CITY OF PUYALLUP

DEVELOPMENT REVIEW TEAM (DRT) LETTER	
PERMIT #	P-21-0025
PROJECT NAME	East Town Crossing Short Plat
PERMIT TYPE	SHORT PLAT APPLICATION
PROJECT DESCRIPTION	Three (3) lot short plat proposal for the subject site
SITE ADDRESS AND PARCEL #	2902 E PIONEER
ASSOCIATED LAND USE PERMIT(S)	
APPLICATION DATE	March 17, 2021
APPLICATION COMPLETE DATE	
PROJECT STATUS	Active Development Review Team (DRT) review case – resubmittal required. Please address review comments below and resubmit revised permit materials and by responding in writing to the remaining items that need to be addressed. To resubmit, please contact your case planner and/or PermitCenter@puyallupWA.gov.
APPROVAL EXPIRATION	N/A – Active permit application, not approved
CONDITIONS	Active permit application, not approved; Pursuant to PMC 20.11.022 regarding inactive applications, any and all pending land use applications or plat applications shall be deemed null and void unless a timely re-submittal is made to the City within 1 year of issuance of this Development Review Team (DRT) comment letter. DRT review letters typically identify requested corrections, studies or other additional required pieces of informatio

Sheet 7 of 8

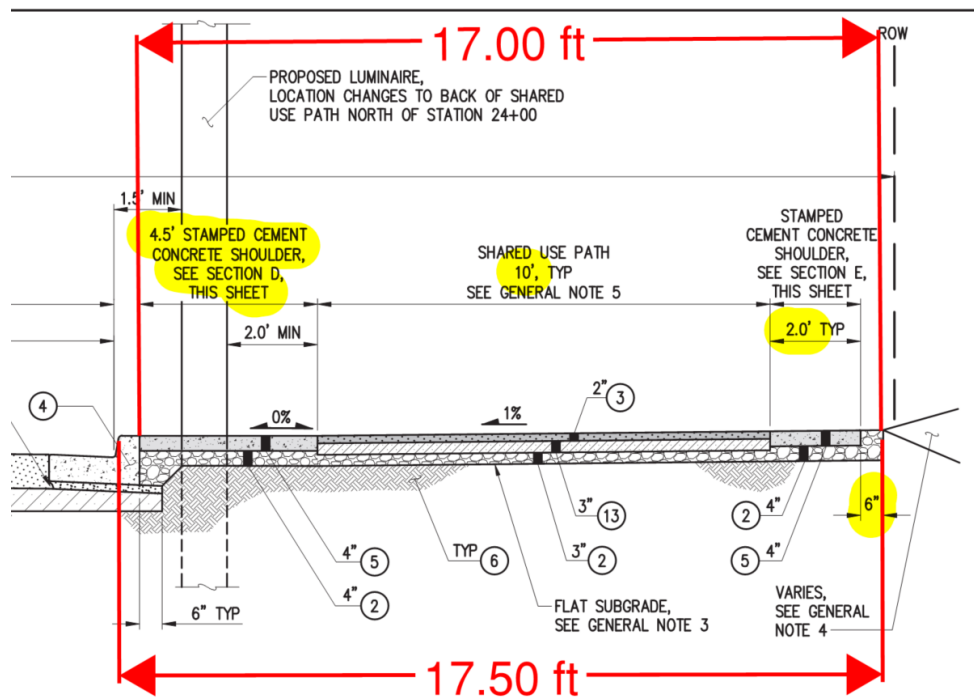
- 72. To maintain the curb alignment through intersection (Face of curb: 34ft from centerline), The City estimates ~52.5ft of ROW dedication is necessary along E Pioneer to construct frontage (0.5ft curb, 10ft planter, 8ft sidewalk). Please provide more information on why 56ft of ROW dedication is necessary along E Pioneer frontage.
- 73. Show ROW dedication/easement for existing traffic signal along Shaw Rd frontage.
- 74. Confirm proposed ROW dedication along Shaw Rd will accommodate shared use path dimensions (17.5ft from face of curb). See exhibit below:
